BARMOUTH NORTH PROMENADE
OUTLINE BUSINESS CASE
BUDGET & SCHEME REVIEW

Ultimate Engineering Solutions Ltd, have been engaged by YGC (Ymgynghoriaeth Gwynedd Consultancy) to review the buildability, budget and risks for the construction of the betterment to Barmouth's North Promenade sea defences, based upon 2 drawings prepared by Arup:

Barmouth North Promenade Buildability Review

Pre - Cast or Cast insitu

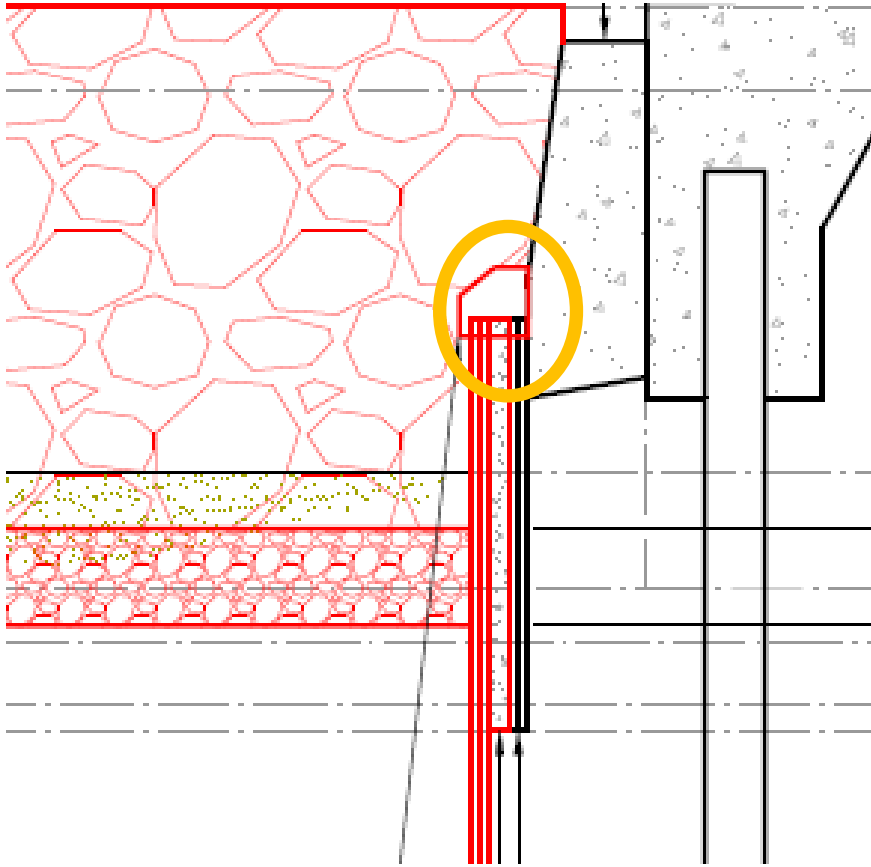
- 1.Improved quality – constructed in factory conditions
2. Repeat shapes lead to reduced costs
- 3.Installation on site is fast - reduces the on site programme
- 4.Reduces plant and resources required on site
- 5.Requires less room on site – delivery just in time

- 1.Requires detailed design to cover every aspect
- 2.Tighter tolerances in initial construction
- 3.Needs careful review of connections
- 4.Restricted to size and weight max 20 T ideally 4 -5 tonne

Pre - Cast or Cast insitu Wave Walls

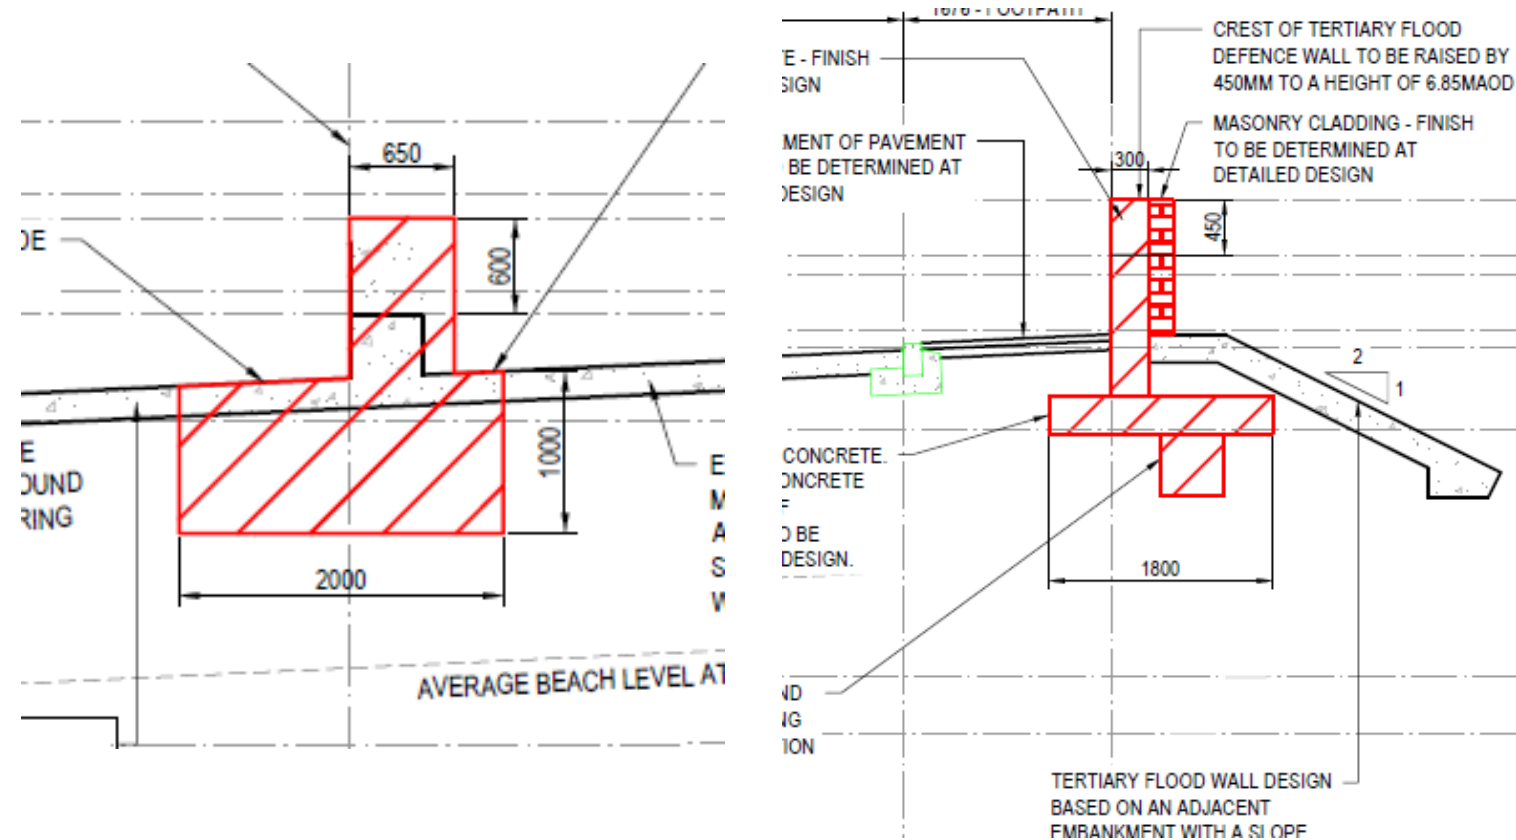
- 1.Requires detailed design to cover every aspect
- 2.Tighter tolerances in initial construction
- 3.Can be precast in various sections
- 4.Restricted to size and weight max 20 T ideally 4 -5 tonne
- 5.Shear key cast insitu?
